RANGER ELECTRIC VEHICLE (EV) TRANSAXLE BOLTS

AFFECTED VEHICLES: ALL 1998-1999 AND CERTAIN 2000 MODEL YEAR RANGER EV

FIGURE 1

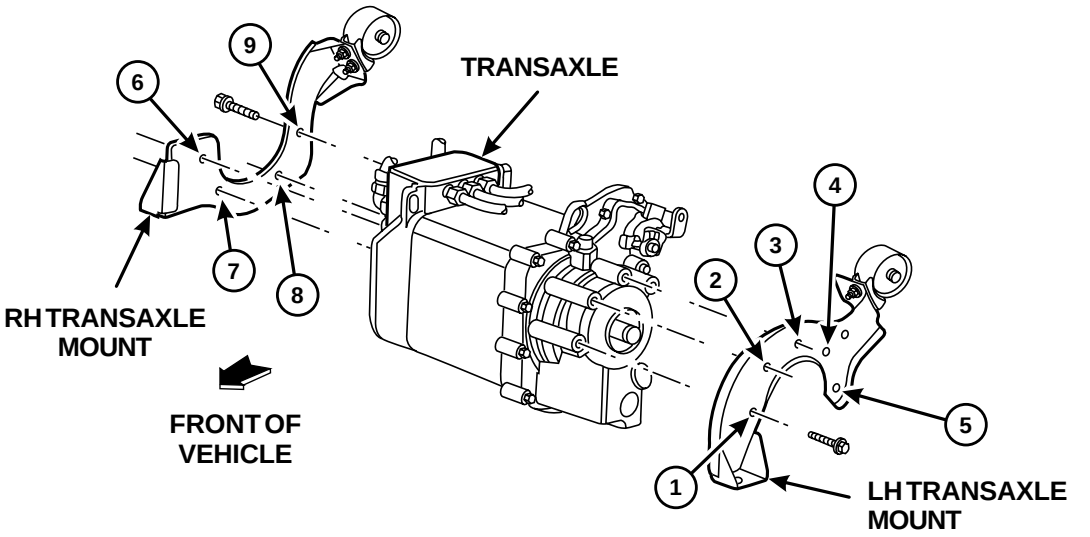
1. Raise and support the vehicle.
2. **CAUTION: Each bolt must be replaced one at a time in the proper sequence (7-8-6-9-3-2-4-1-5) and fully tightened immediately after installing. Failure to do so will damage the transaxle.**

Replace the transaxle bolts one at a time following the sequence shown at the bottom of the illustration. See Figure 1. All of the bolts are accessible with the torque wrench and socket except the No. 1 and No. 6 bolts. The No. 1 bolt will require the use of the wobble extension. The No. 6 bolt will require the use of the torque adapter. If present, clean all residual Loctite® from the threaded holes in the transaxle with brake cleaner and compressed air. Tighten each bolt to the following specifications immediately after installing.
   - Tighten all bolts except No. 6 to 130 Nm (96 lb-ft).
   - Tighten bolt No. 6 (with torque adapter) to 123 Nm (91 lb-ft).
3. Lower the vehicle.
